Addendum 1 for RFB 952600-01

Project Name: DPS Post 2 - Parking Lot Replacement

DAS Project #: 9526.00

Addendum No. 1 Items:

D.01

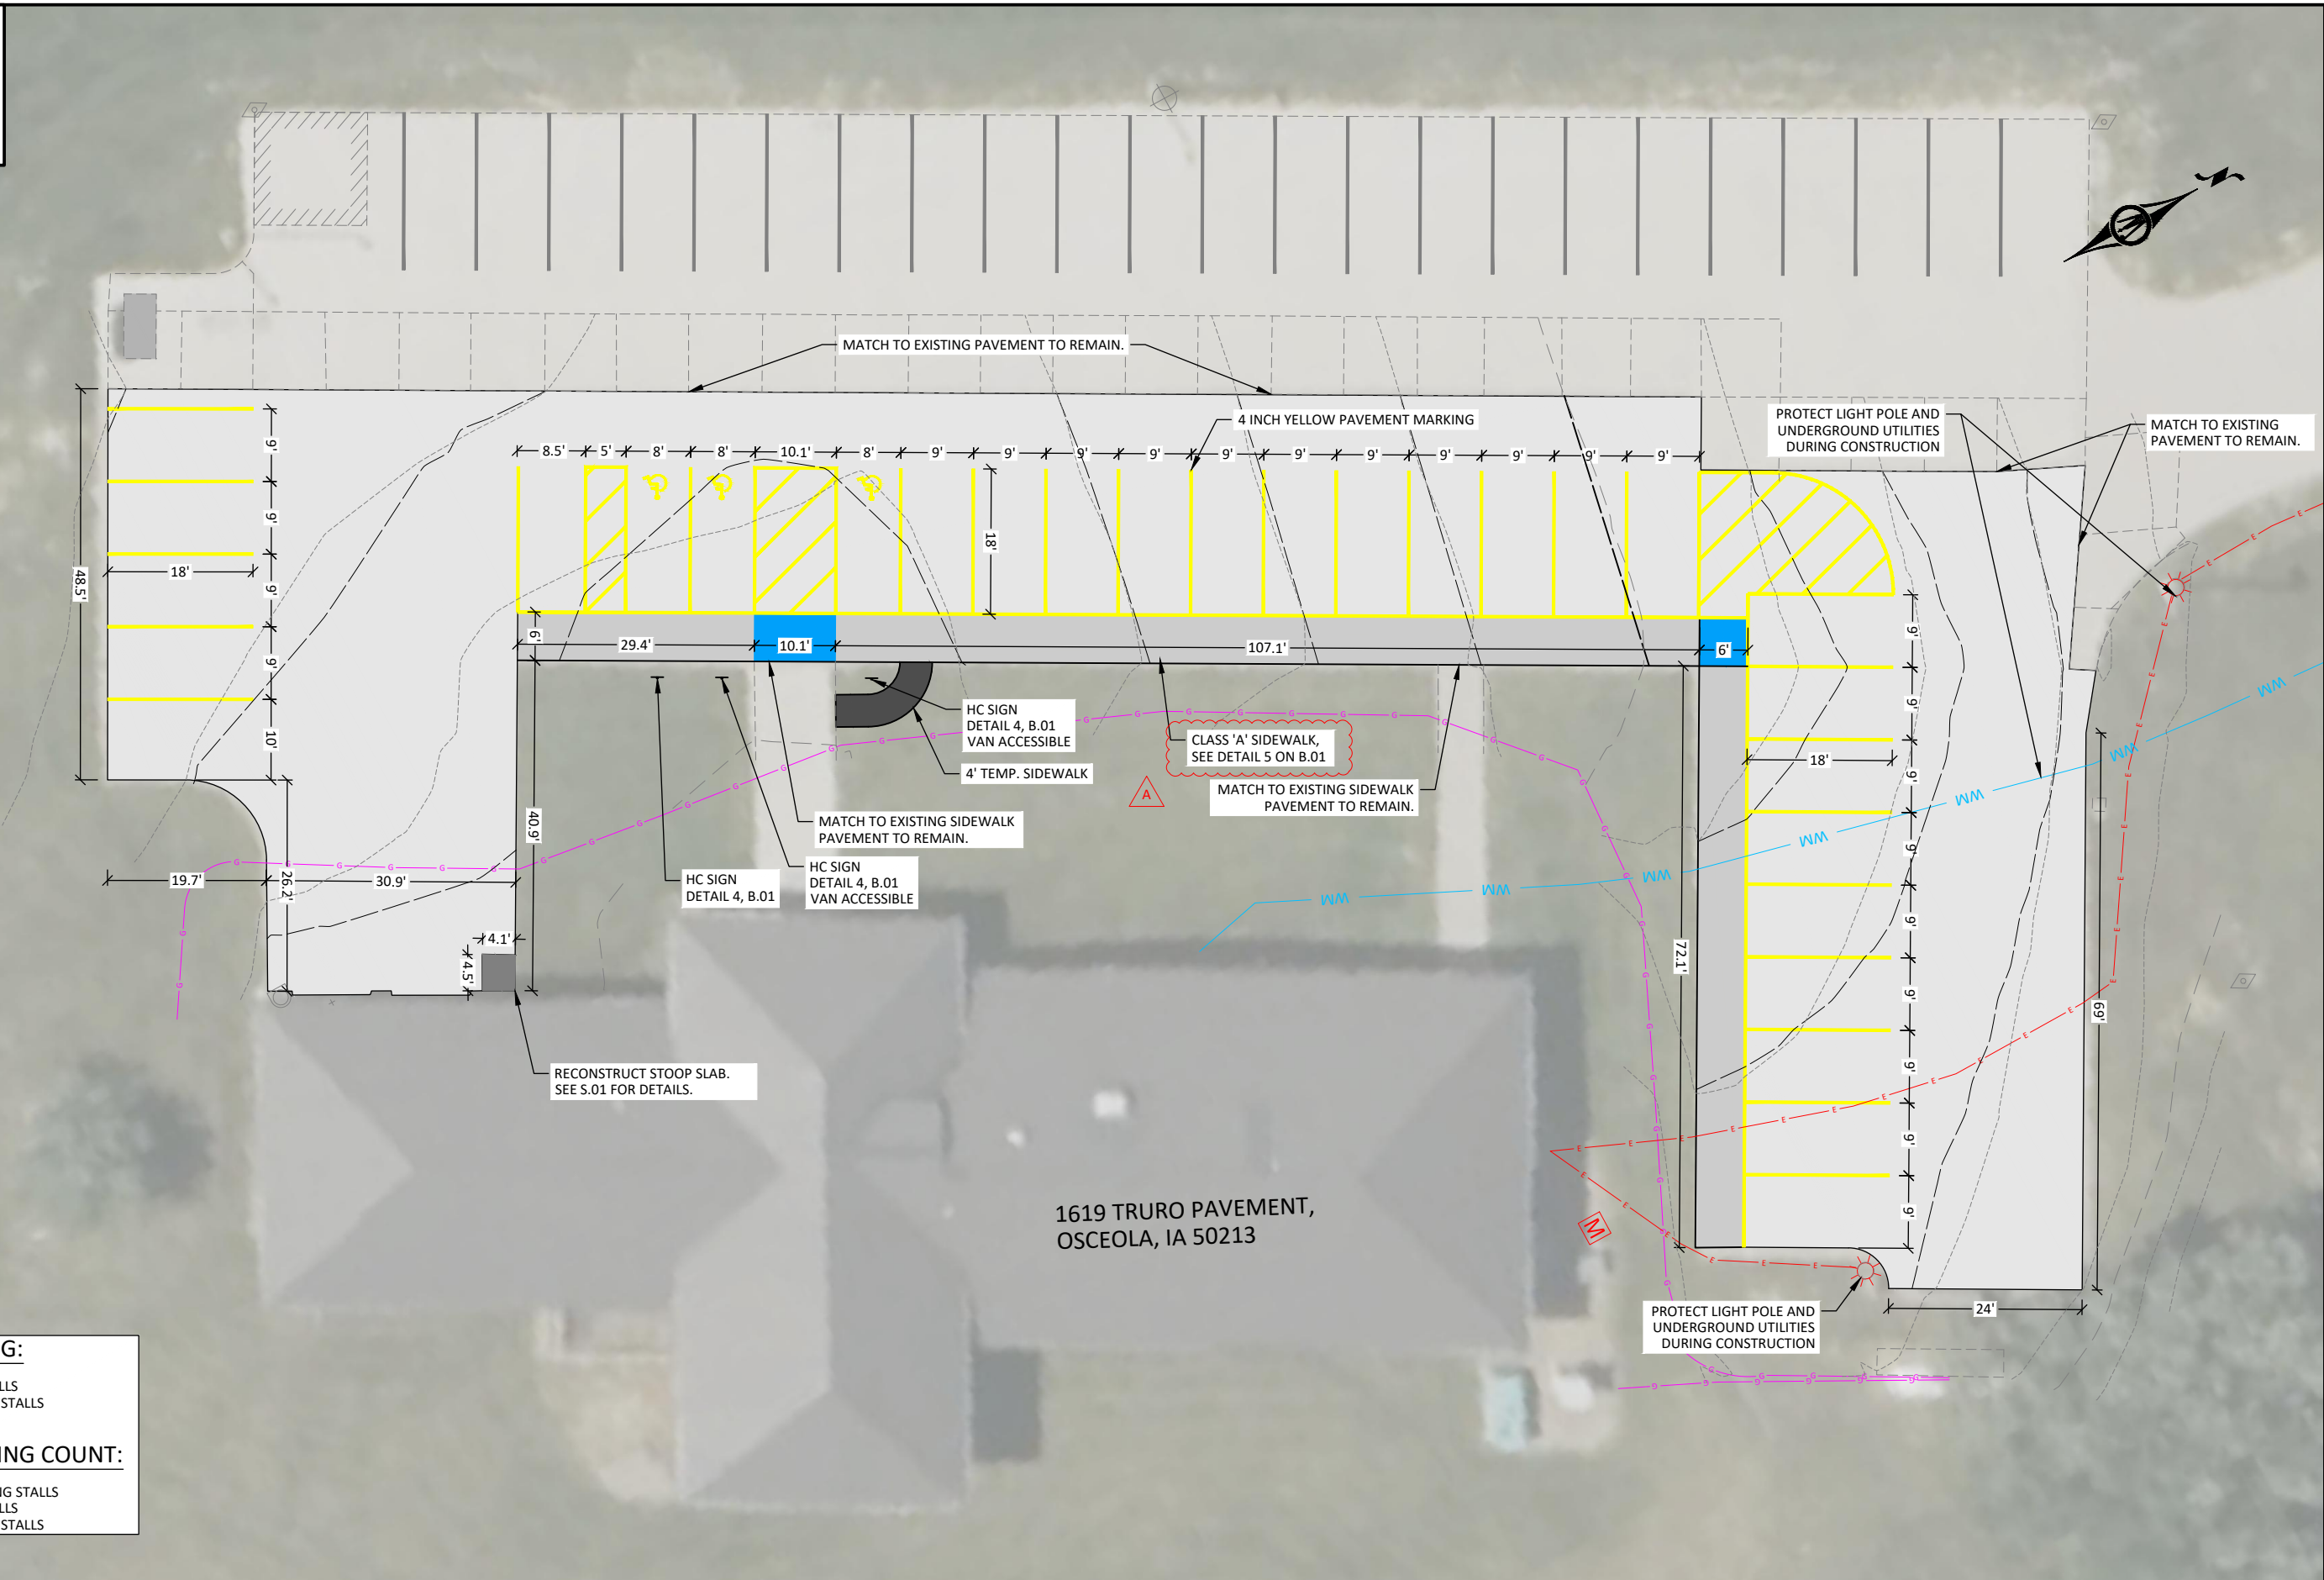
1. Addendum #1 Updates From Bolton & Menk
 - a. A.01: Update seals
 - b. C.01: Address pavement marking glass spheres as not required
 - c. D.01: Addressing note for Sidewalk detail

- b. Question 2: B.01 missing detail #6
 - i. Response 2: Note is to remove the reference to detail #6, and just detail #5 – see revised sheet D.01
 - c. Question 3: Does this parking lot require Salt Guard?
